# Groundwater Transfer Review Summary Form

Transfer/PA # T- 13524 (J.R. Simplot: J.R.S. Properties III, LLP)

GW Reviewer Gerald H. Grondin

Date Review Completed: 24 November 2020

# Groundwater Transfer Application T-13524 (Temporary) JR Simplot Properties III, LLP (To Wells)

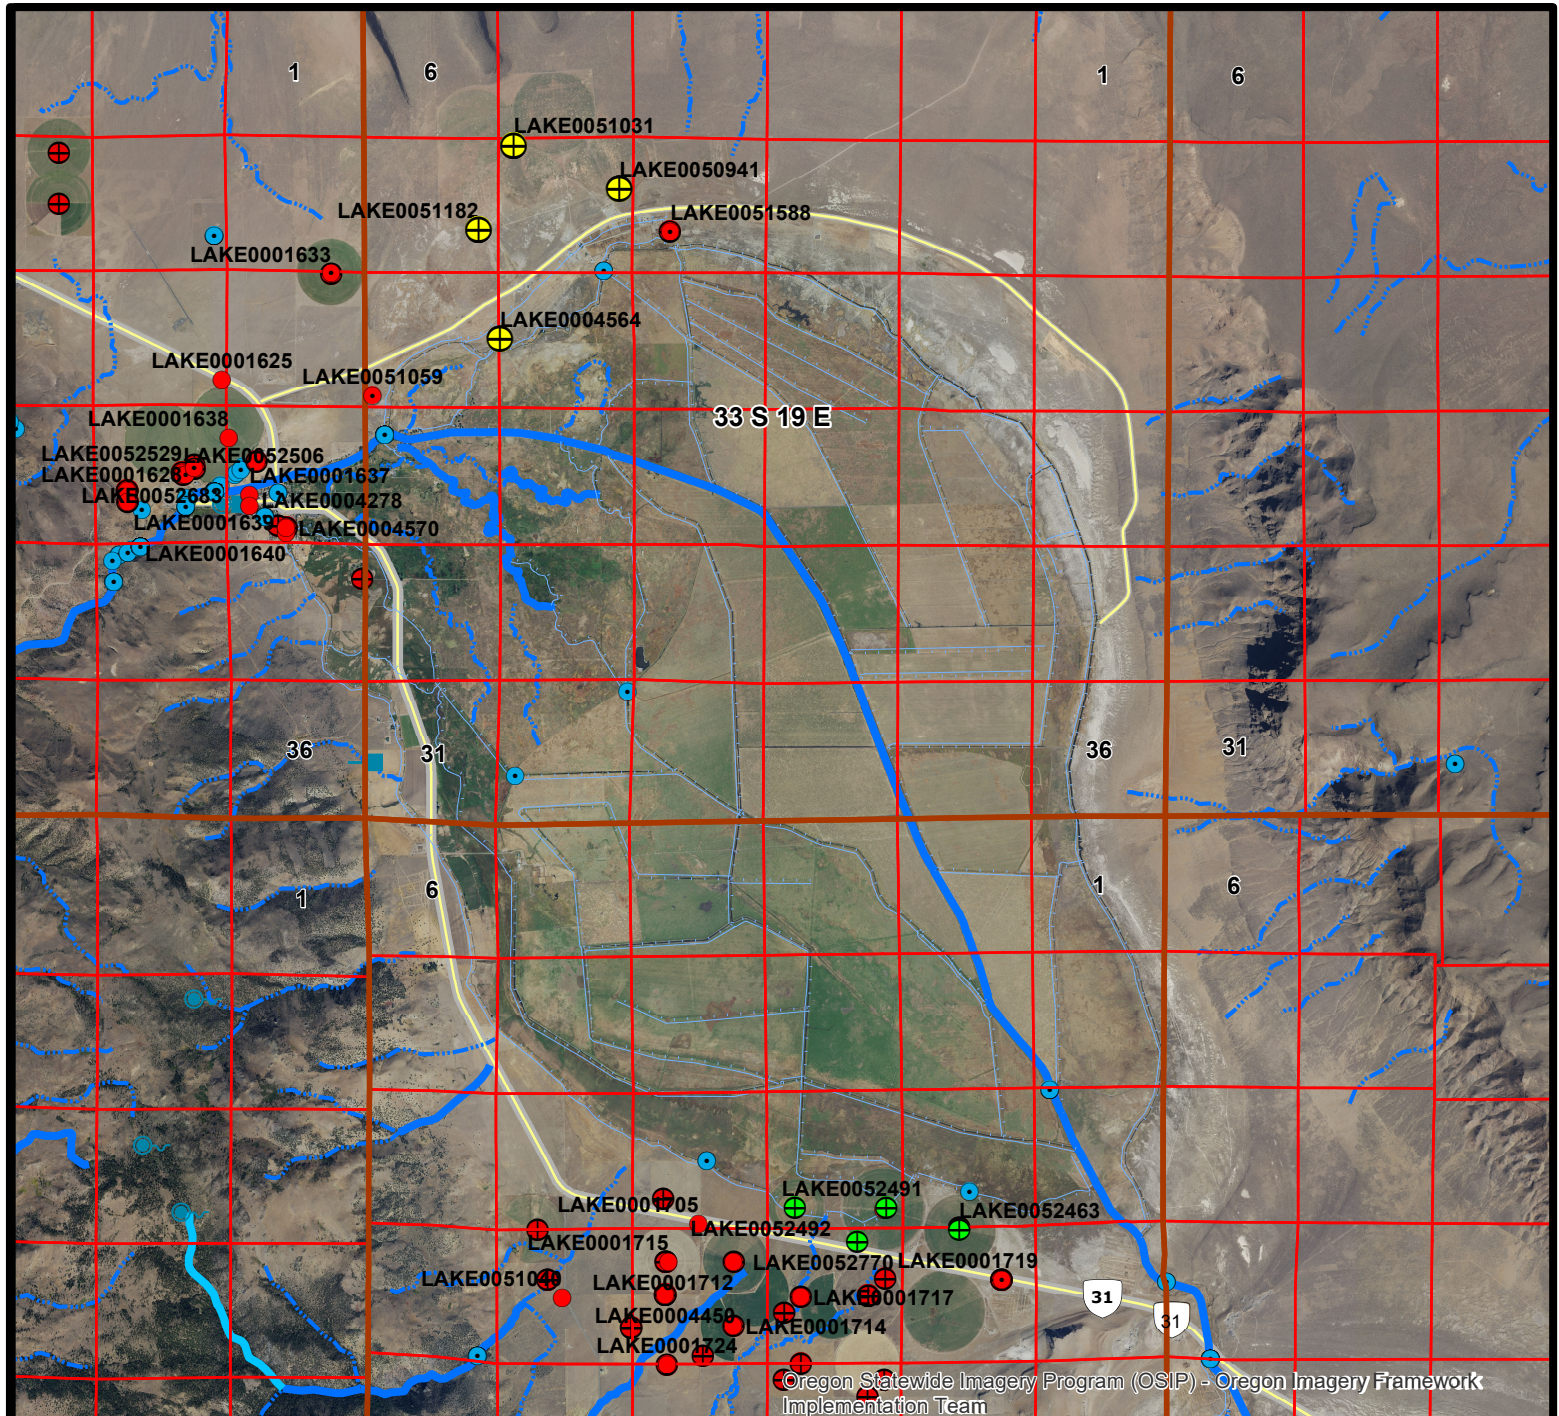
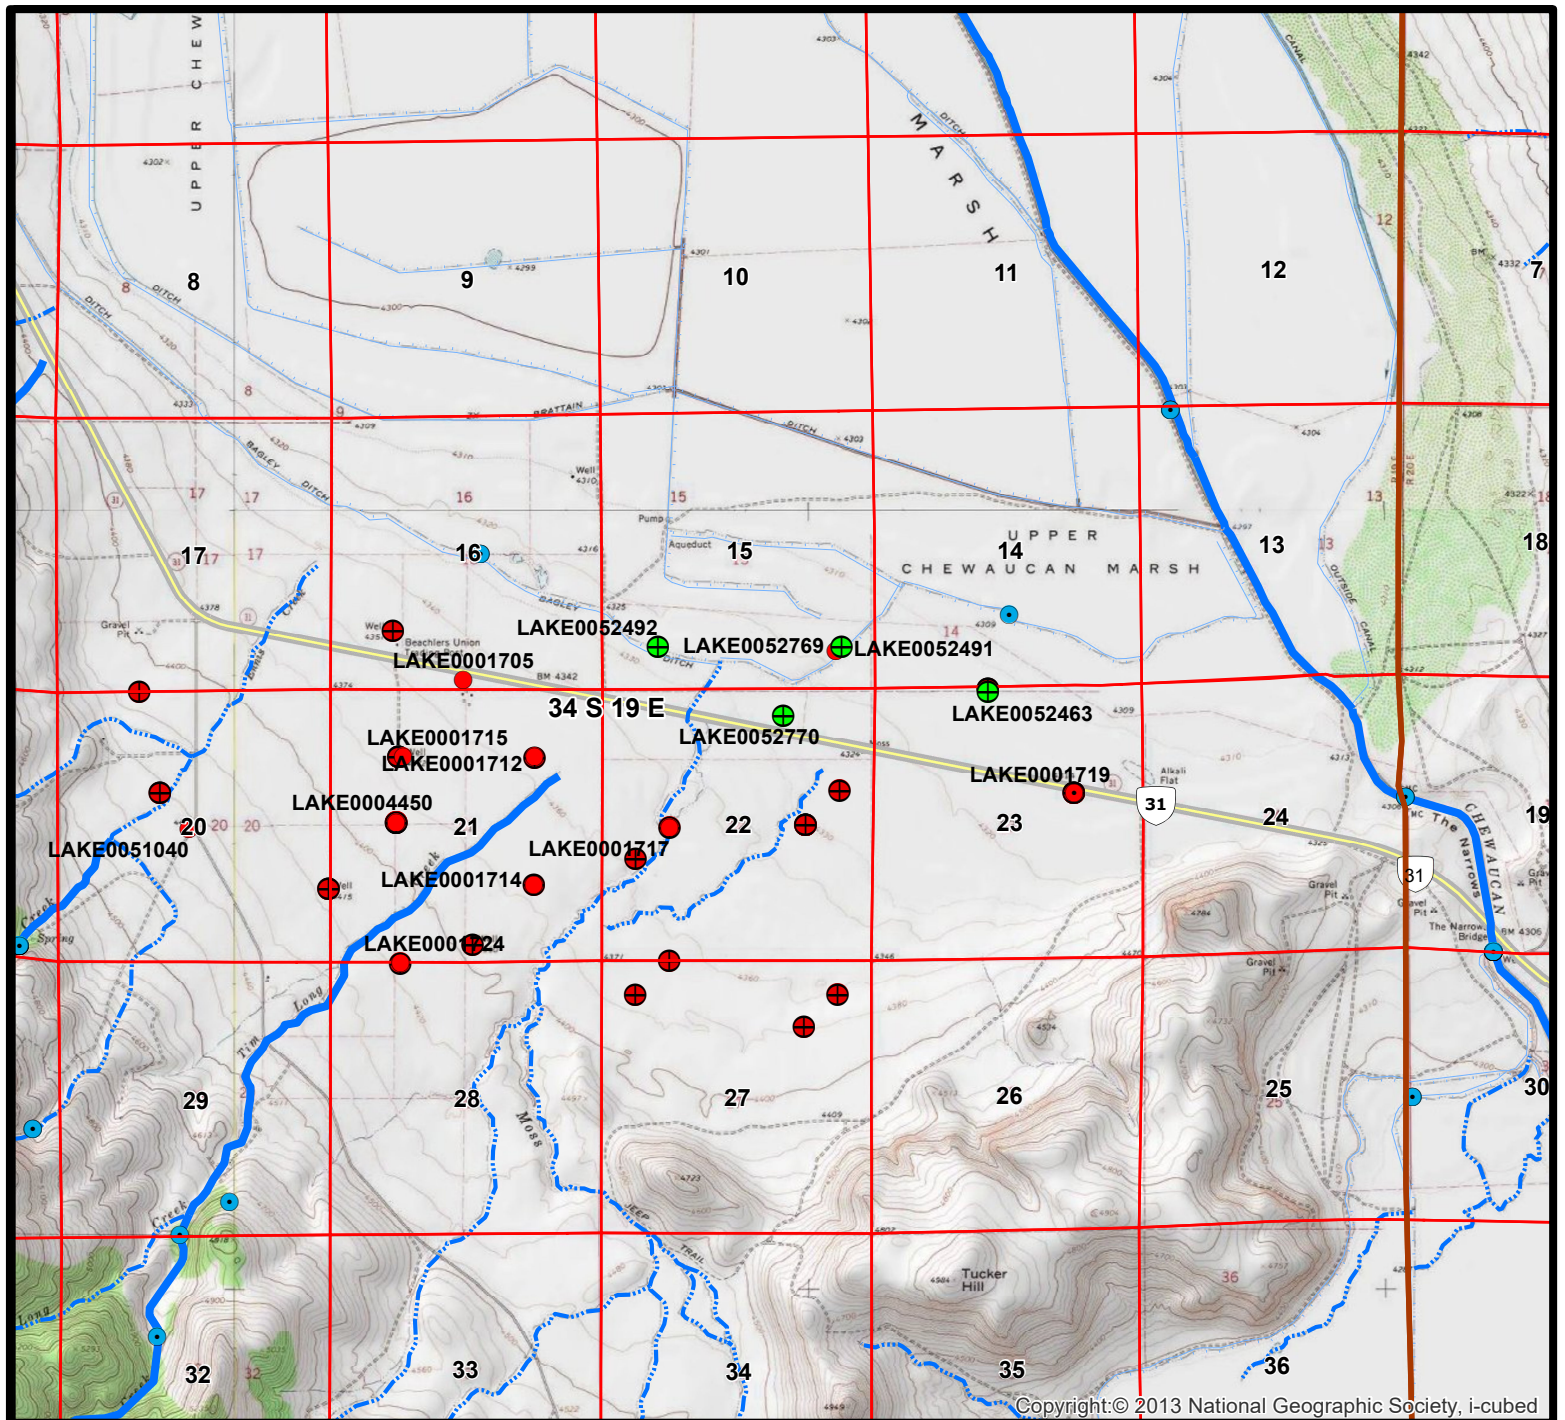
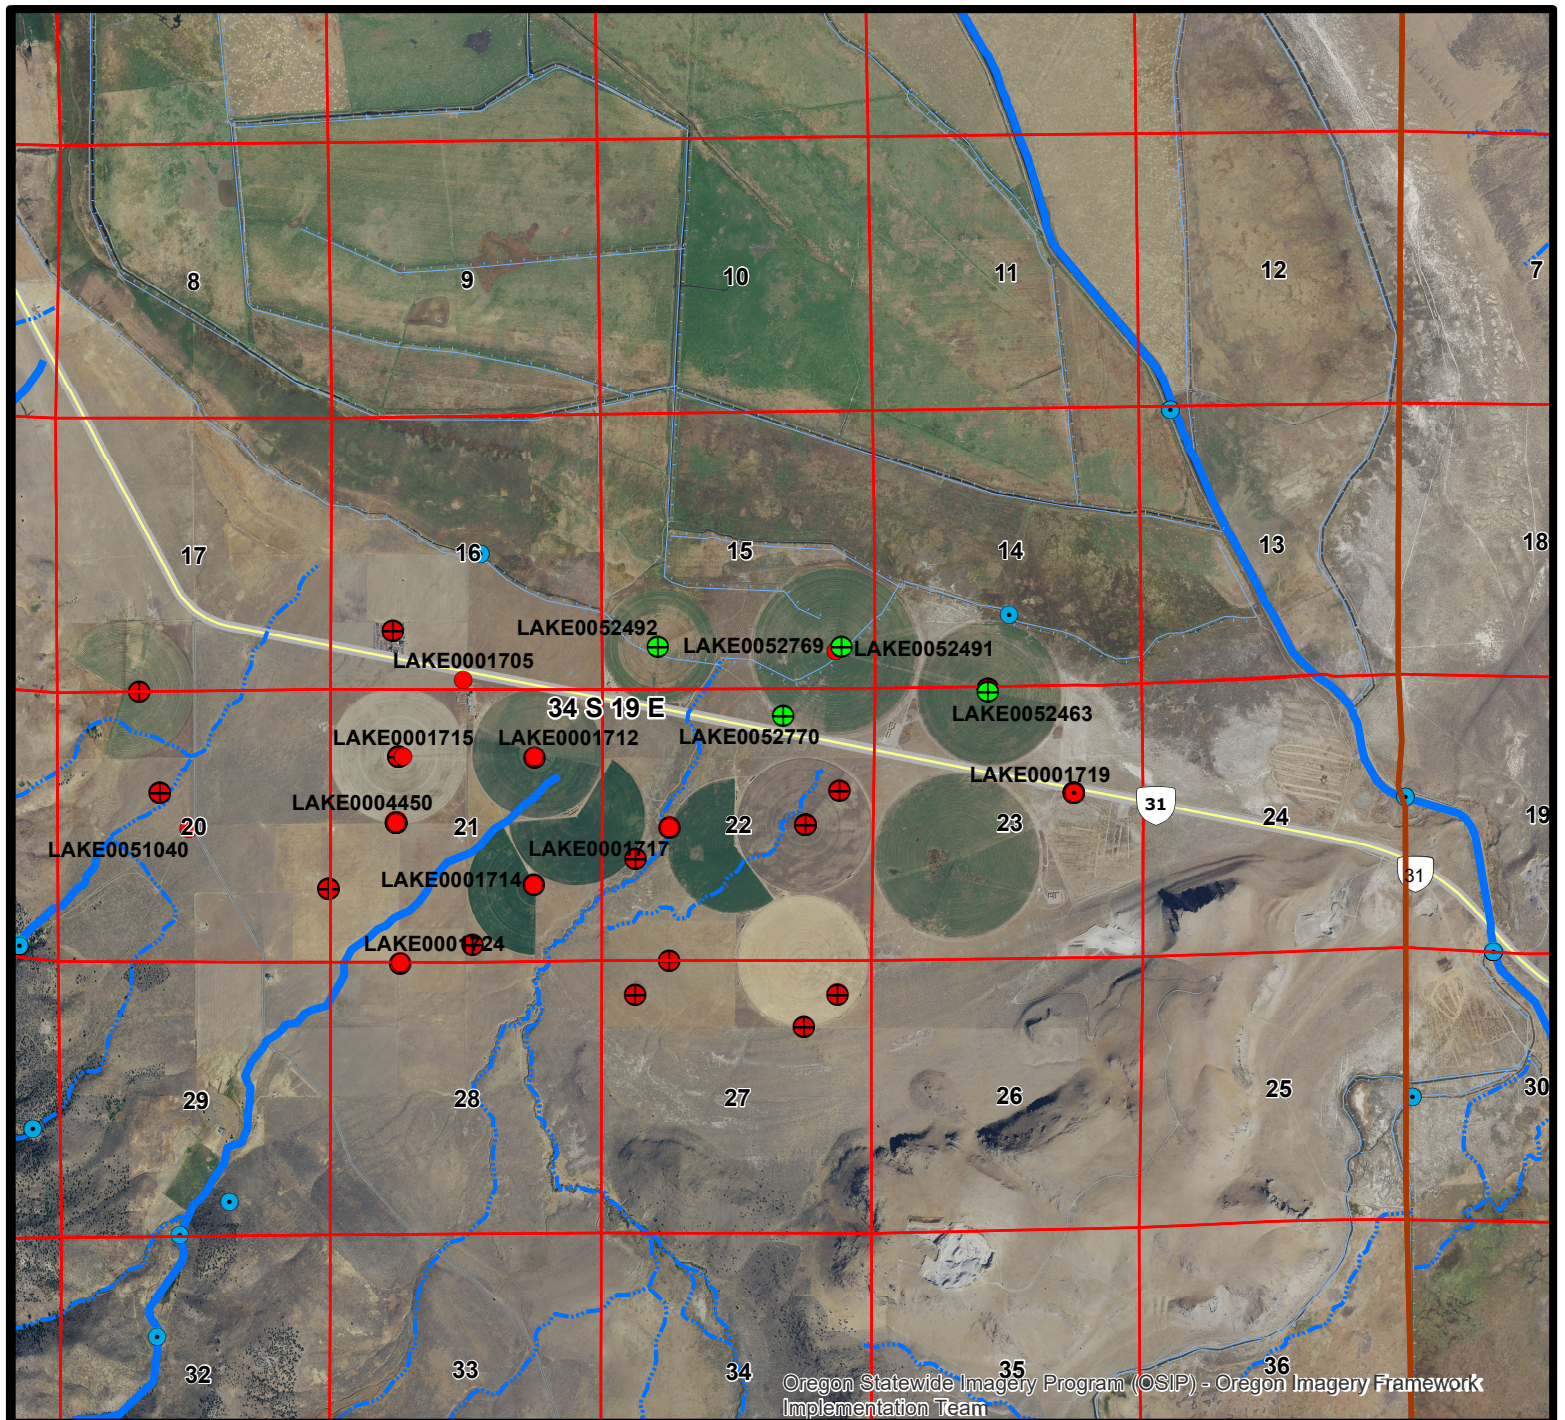
**Yes.** The proposed change will move groundwater pumping about 6.8 to 8.8 mile south from the north side of Upper Chewaucan Marsh to the south side of Upper Chewaucan Marsh (see attached maps). The proposed change will move groundwater pumping closer to a different set of groundwater right wells (see attached maps).
